ATLANTIC CROSSING

Project Number: 217093

#### CLASS II MODIFICATION 2019 - 8.2.2019

PLAZA SUPPLEMENTAL EXHIBITS

BLDG VI ELEVATIONS

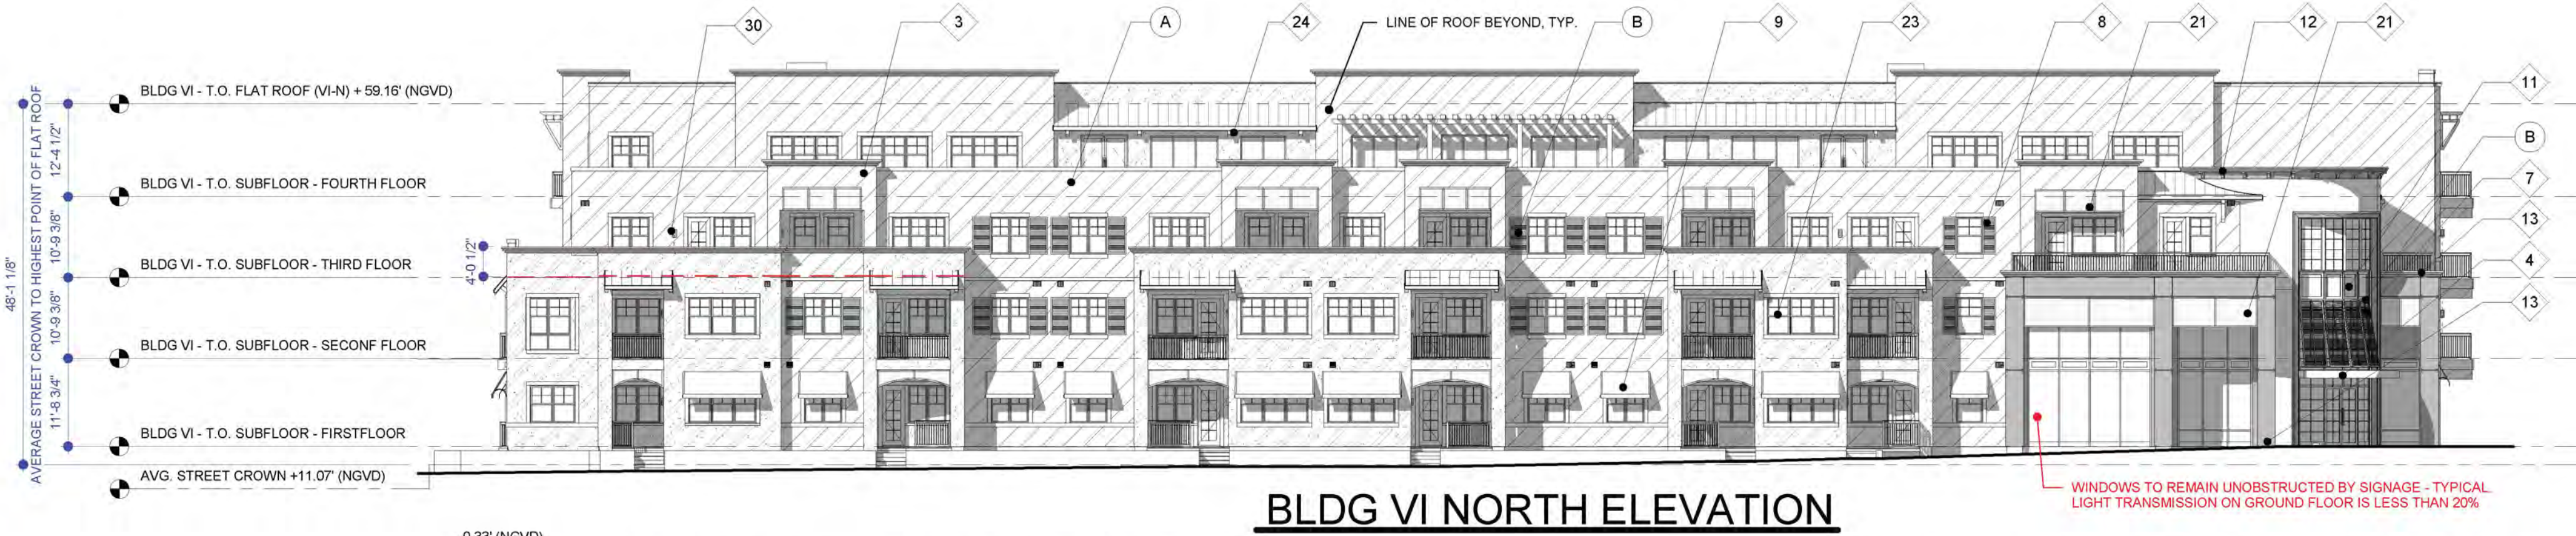
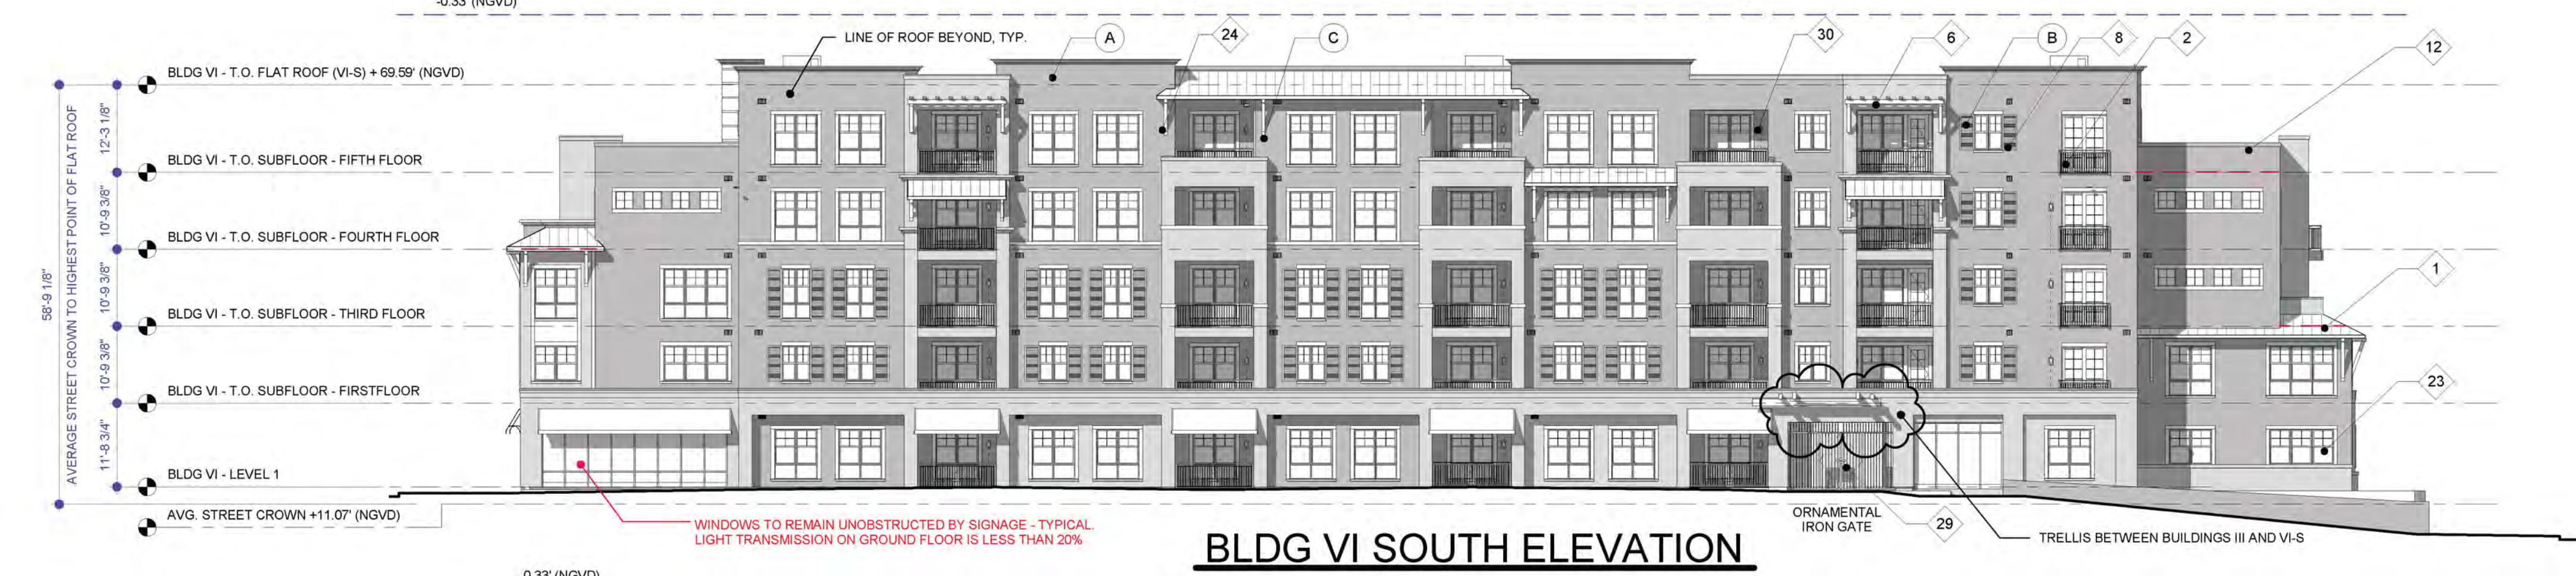
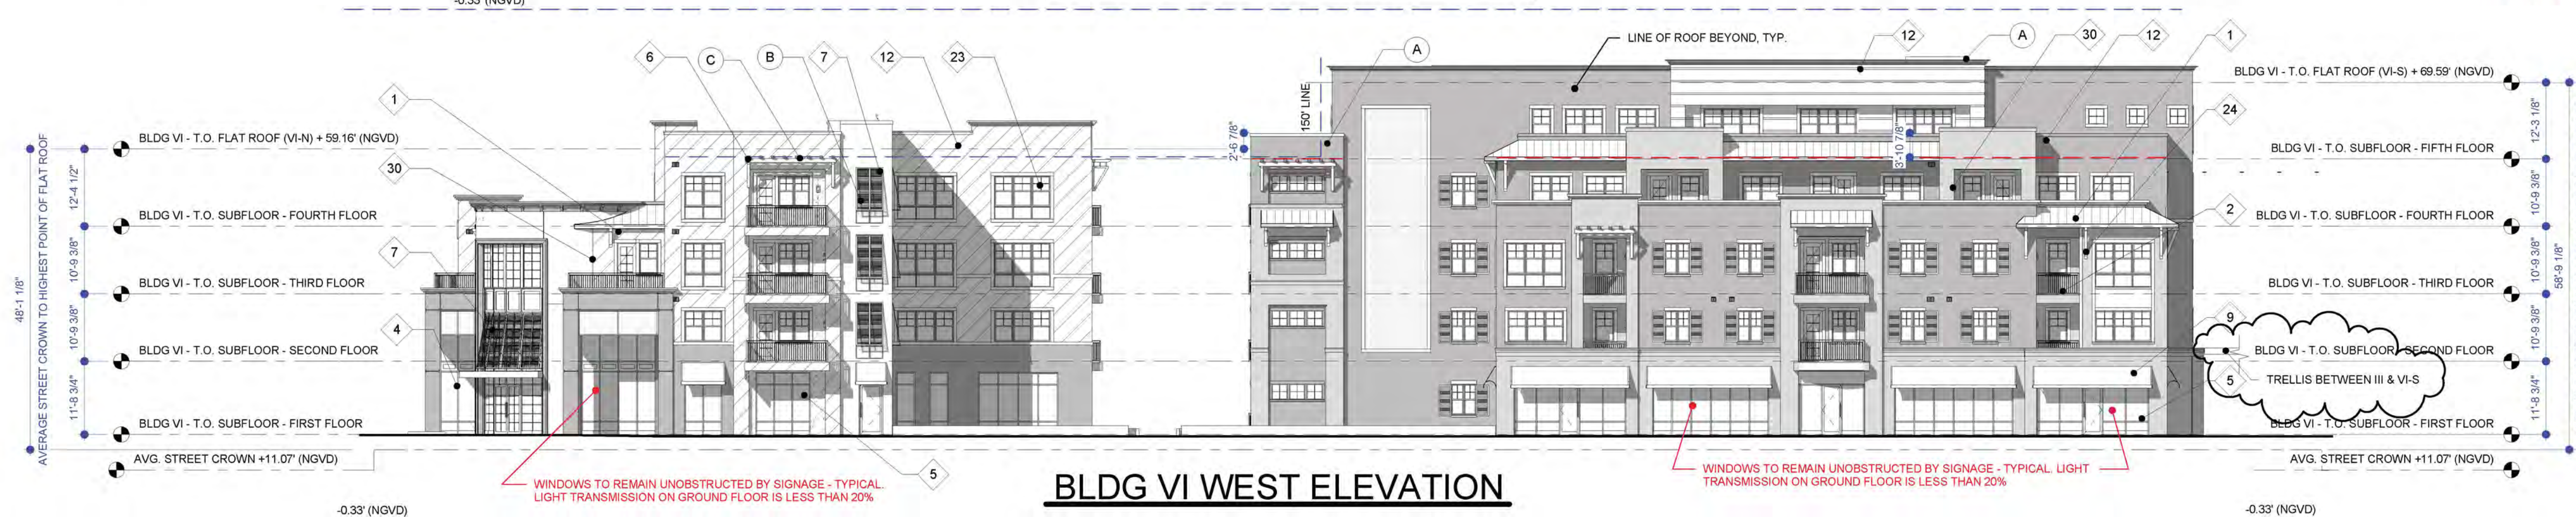
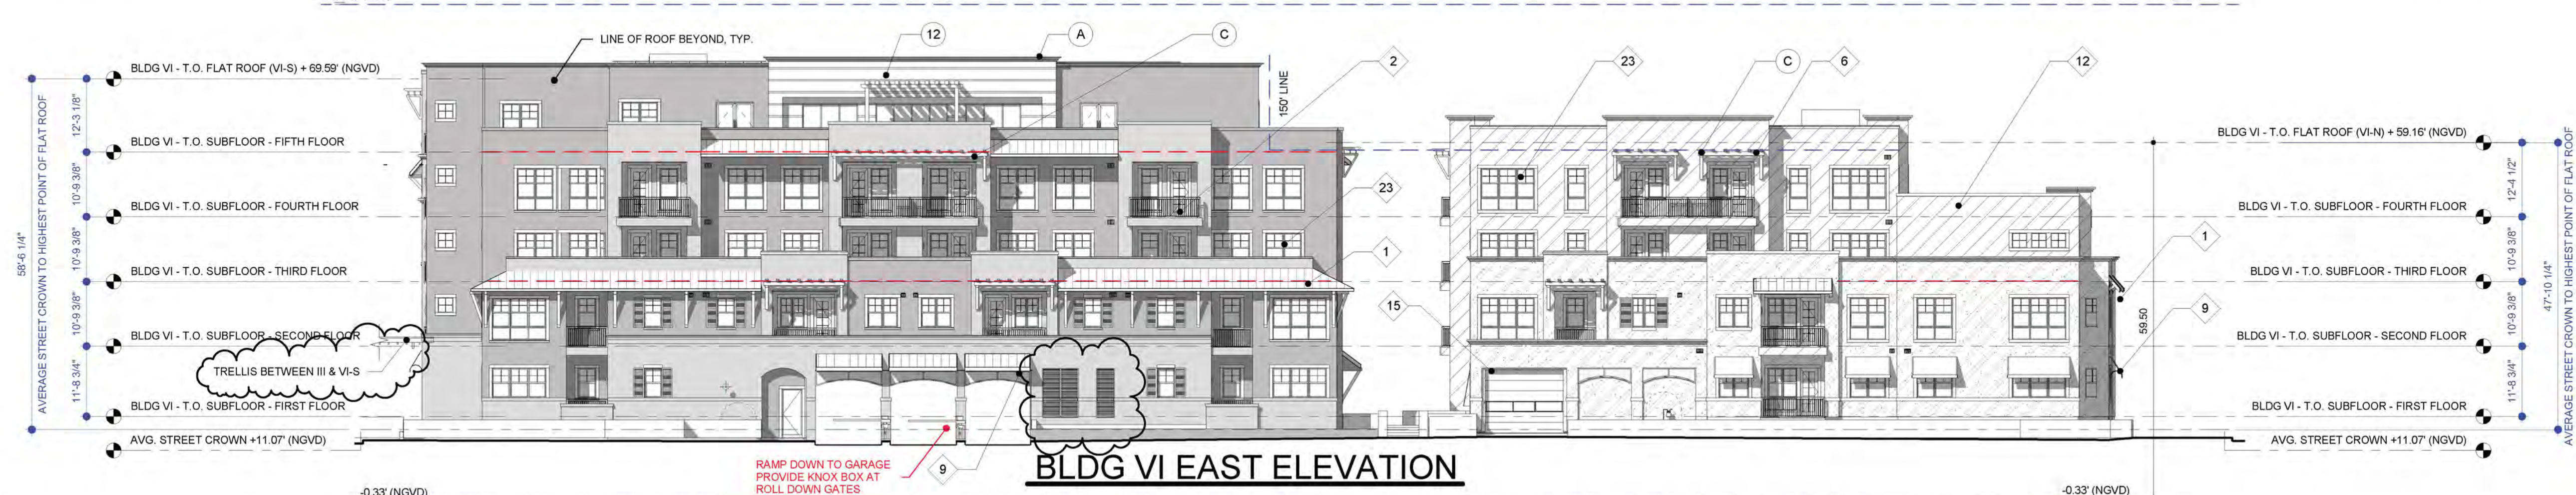
RESPONSE TO 2.12.14 STAFF COMMENTS  
• WINDOWS OF THE BUSINESSES AND OFFICES REMAIN UNOBSTRUCTED BY SIGNAGE  
• LIGHT TRANSMISSION FOR GROUND FLOOR GLASS AREA TO BE NO GREATER THAN 20%  
• KNOX BOXES TO BE PROVIDED AT ROLL DOWN GATES  
• ADJUSTED METAL AWNINGS AND ADDED MORE SHUTTERS

SETTLEMENT MODIFICATION 4.21.2017  
• RELOCATED ENTRY TO PARKING GARAGE  
• ADJUST EAST AND SOUTH DUE TO PARKING GARAGE ENTRY RELOCATION

- STRENGTHENING PEDESTRIAN SCALE OF ENTRY TO LEASING (NORTH-WEST CORNER)
- ENHANCED HORIZONTAL DETAILING AT BASE - ADDED ROOF FORMS, CONSOLIDATED COLOR, MINIMIZED TALL SLENDER VERTICAL FORMS
- ENHANCE DETAILING AT BUILDING CAP
- ENHANCE DETAILING AT BUILDING CORNERS

CLASS II MODIFICATION 8.2.2019  
• ADD TRELLIS BETWEEN III & VI-S

1 PLAZA ACCESS TO GARAGE - AFTER  
1/8" = 1'-0"

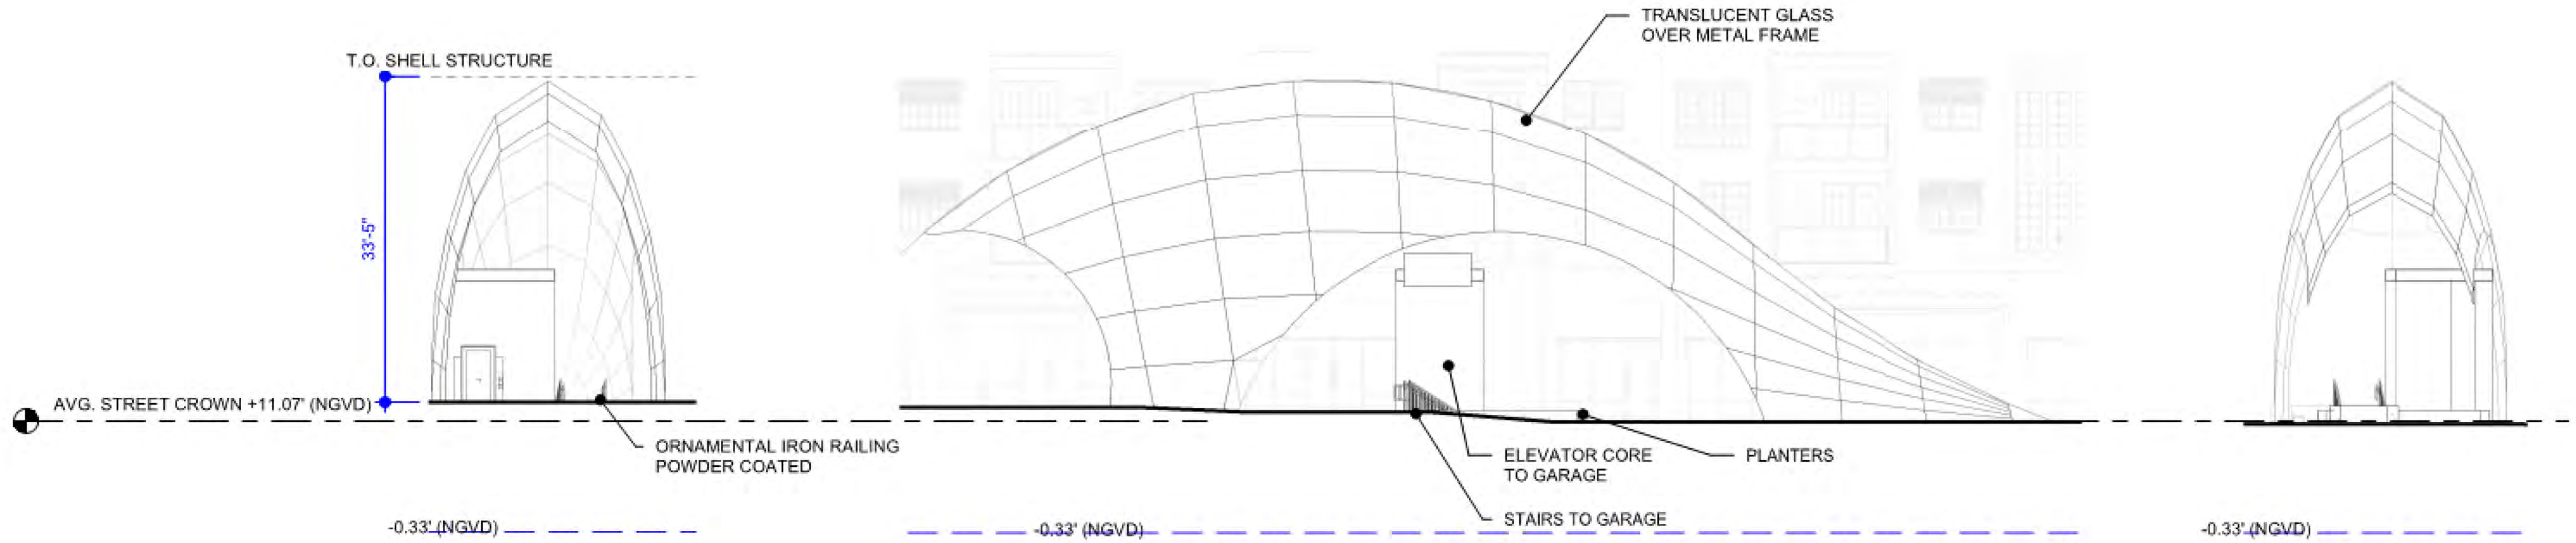
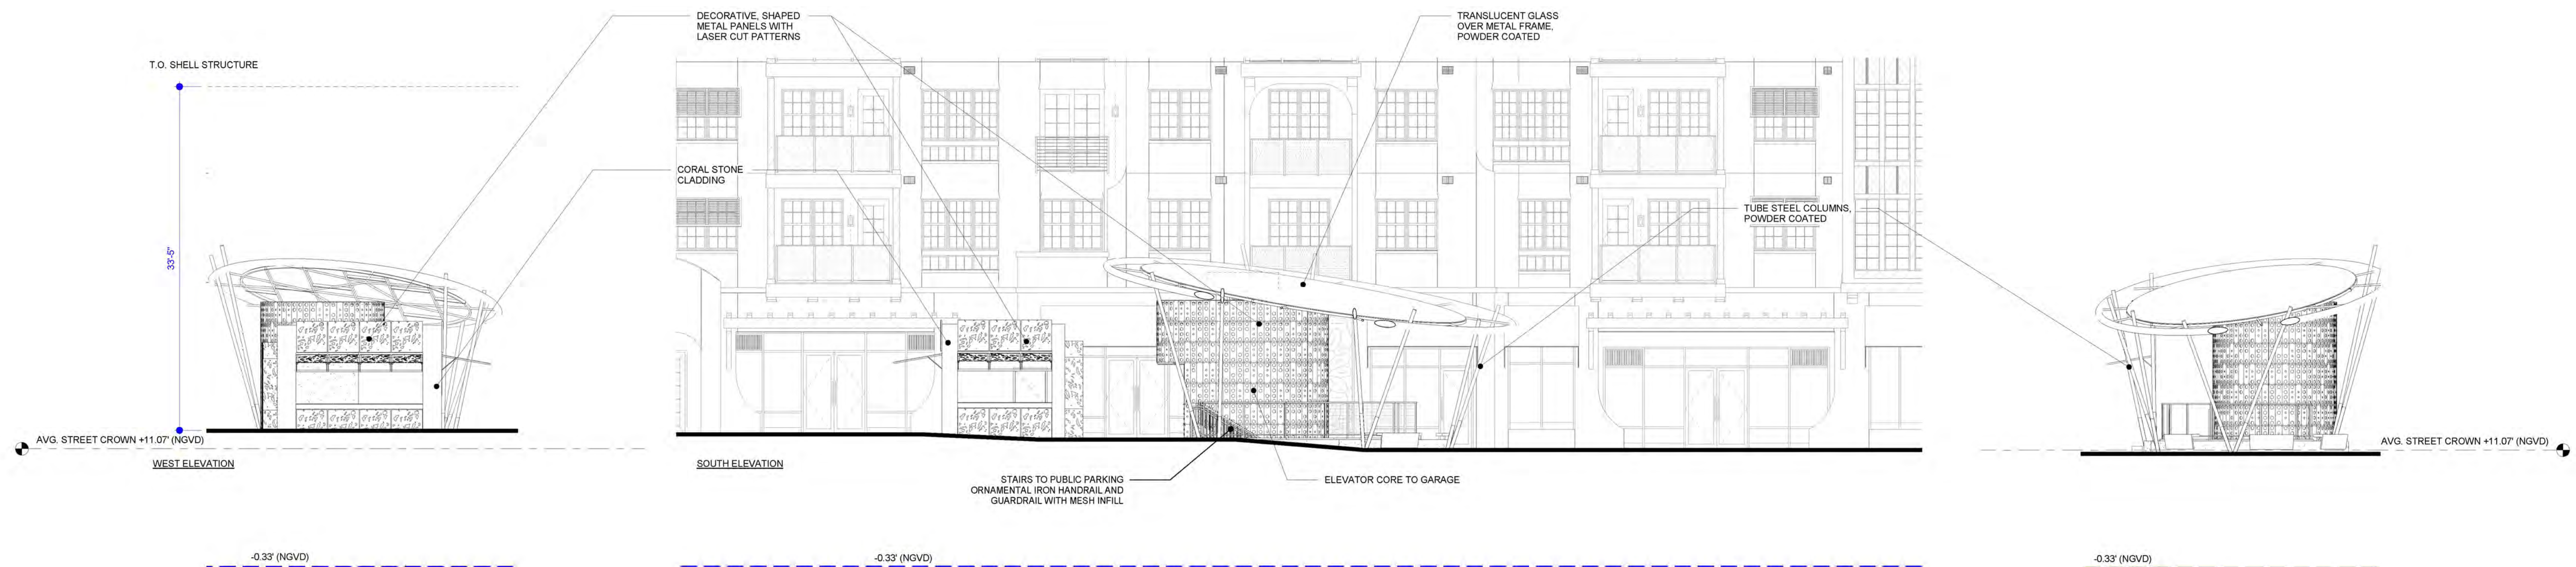
2 PLAZA ACCESS TO GARAGE - SHELL CONCEPT BEFORE  
1/8" = 1'-0"

1 BUILDING VI-S MAILROOM ENTRY - BEFORE  
1/4" = 1'-0"

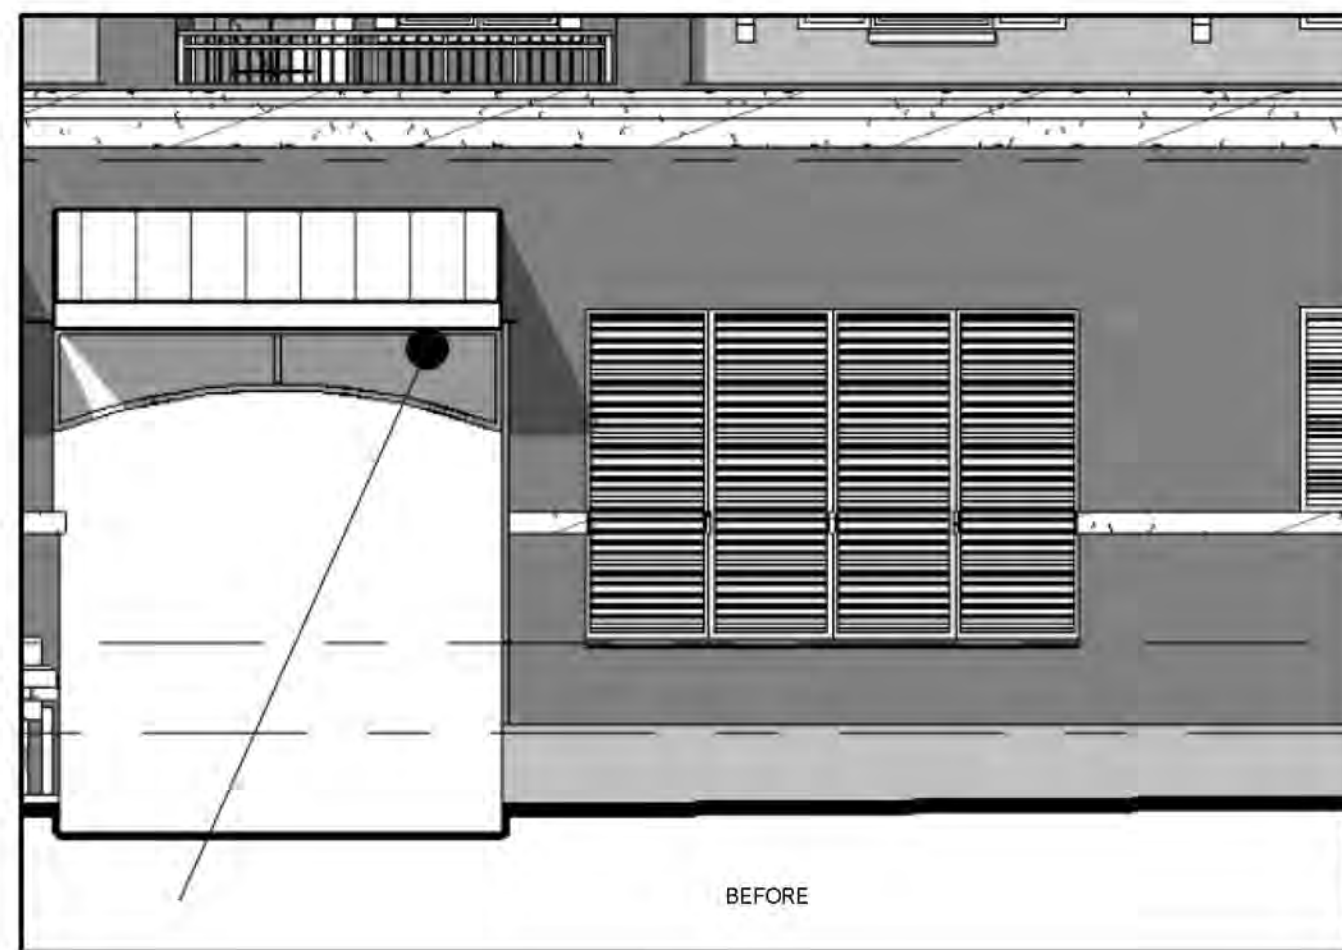
ADDED TRELLIS TO ORIENT  
PEDESTRIAN CROSSING. ALSO  
PROVIDE TRAFFIC CALMING

ADDED WINDOWS (RELOCATED  
FIRE PUMP ROOM TO BUILDING III)

2 BUILDING VI-S LOUVERS AT WALL ADJACENT TO GARAGE RAMP  
1/4" = 1'-0"

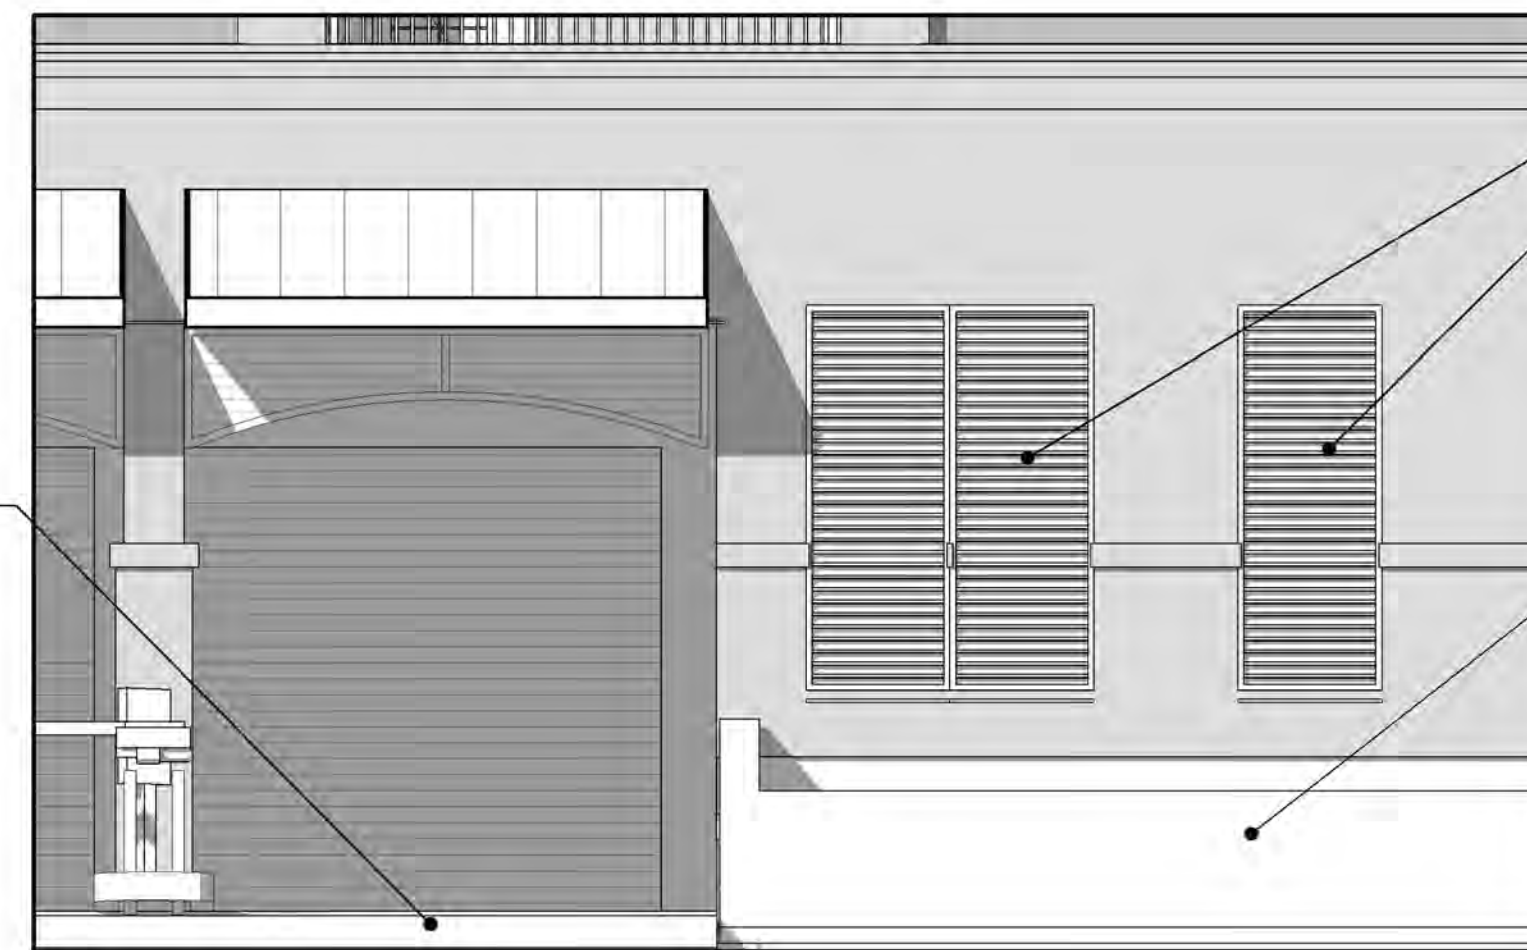
CORRECTED LEVEL OF  
ENTRY AT GARAGE RAMP

MODIFIED COMPOSITION OF LOUVERS

DETAILED TALLER PLANTER WALL
